Memorandum

PDC05-122. PLANNED DEVELOPMENT REZONING PERMIT TO ALLOW THE REZONING OF A PROPERTY FROM THE R-M MULTI-FAMILY RESIDENCE ZONING DISTRICT TO THE A(PD) PLANNED DEVELOPMENT ZONING DISTRICT TO ALLOW ONE SINGLE FAMILY DETACHED RESIDENCE AND UP TO 13 SINGLE-FAMILY ATTACHED RESIDENCES ON A 0.74 GROSS ACRE SITE LOCATED ON THE EAST SIDE OF RADIO AVENUE, APPROXIMATELY 160 FEET NORTH OF LINCOLN COURT, (2102 RADIO AVENUE) (WILLOW VILLAGE SQUARE, LLC PAUL MAJOULET, OWNER).

CITY OF SAN JOSÉ, CALIFORNIA Planning, Building and Code Enforcement 200 East Santa Clara Street, San Jose, CA 95113-1905	Hearing Date/Agenda Number PC: 7/18/2007 Item: CC: 8/14/2007 Item:
	File Number: PDC05-122
STAFF REPORT	Application Type: Planned Development Prezoning
	Council District: 6 / SNI: None
	Planning Area: Willow Glen
	Assessor's Parcel Number: 439-08-014

LAND USE PLAN 1/16" = 1'-0"

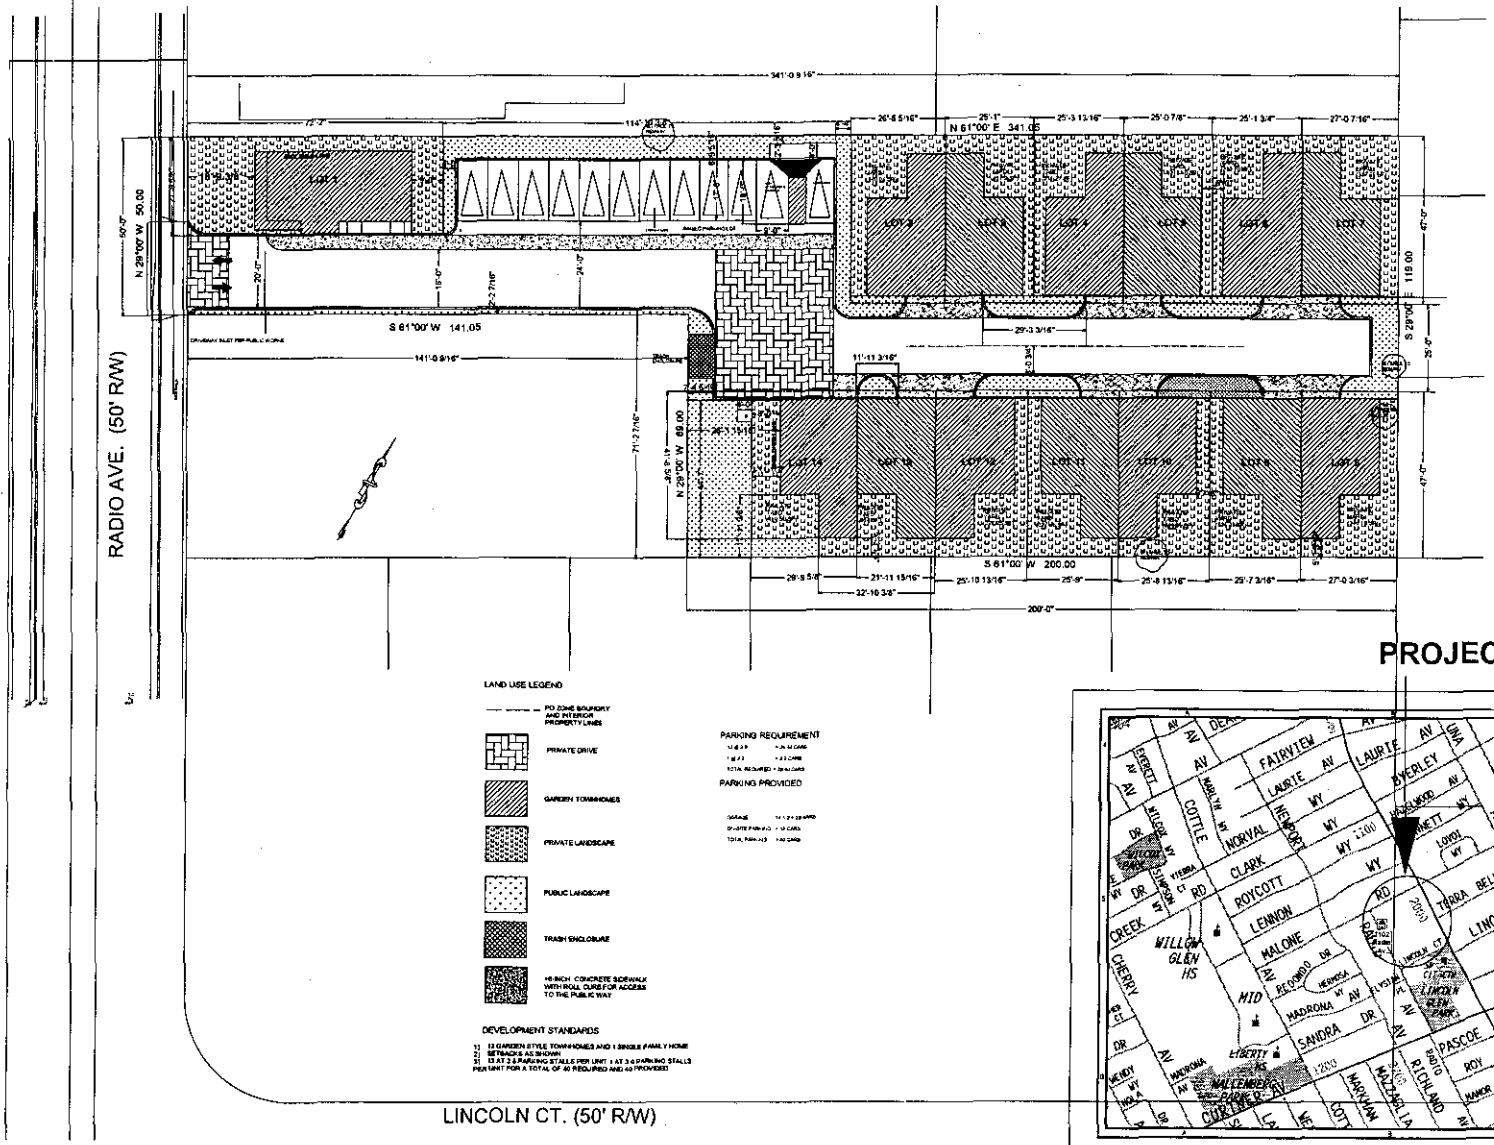
Commissioner Kinman inquired about the location of the trash and recycling enclosure and containers. She asked if the trash and recycling containers will be serviced on the site or pushed to the street, if the units would be owner occupied, and if laundry rooms were provided in the units. The applicant stated that waste management services would occur on the site. He stated the units will be owner occupied, and laundry rooms are proposed on the second level of each unit.

Commissioner Kinman asked about the divergence from the Residential Design Guidelines recommendation of 400 square feet of private open area, down to 300 square feet of proposed private open space per each attached unit. Staff explained that additional open space might not be able to be provided on the site without decreasing the number of proposed units. Staff explained that while the project is not required to provide common open space, 1,000 square feet of common open space is proposed in the southwestern corner of the site.

Commissioner Zito asked why a five-foot setback is proposed from the southern property line that borders the rear yards of adjacent single-family detached residences. Staff explained that the two- and three-story living elements are required to be set back approximately 20 feet from the southern property line, and the proposed five-foot setback is only for one-story tandem garages. Staff stated this was considered because a detached garage could be built at the rear property line in the conventional R-1 Residence Zoning district.

Commissioner Kamkar asked if four units, numbered six, seven, eight and nine on the plans, could be eliminated to allow additional room on the site to accommodate additional parking spaces and to increase the overall size of the units. He stated he understood that this is not to the developer's favor, but that in this case, the limits were pushed too far. He stated that there are too many proposed units on the site, that the inclusion of the 1,000 square-foot common open space area does not compensate for the minimal amount of private open space, that the driveway is too narrow for the number of units, and even for this difficult site, it is just not a good design.

- Up to one single-family detached residence
- Up to 13 single-family attached residences
- At least 50%, or more, of the attached units shall have a two-car side-by-side garage
- A minimum of 400 square feet of private open space is required for each unit
- A minimum of 1,000 square feet of common open space is required.
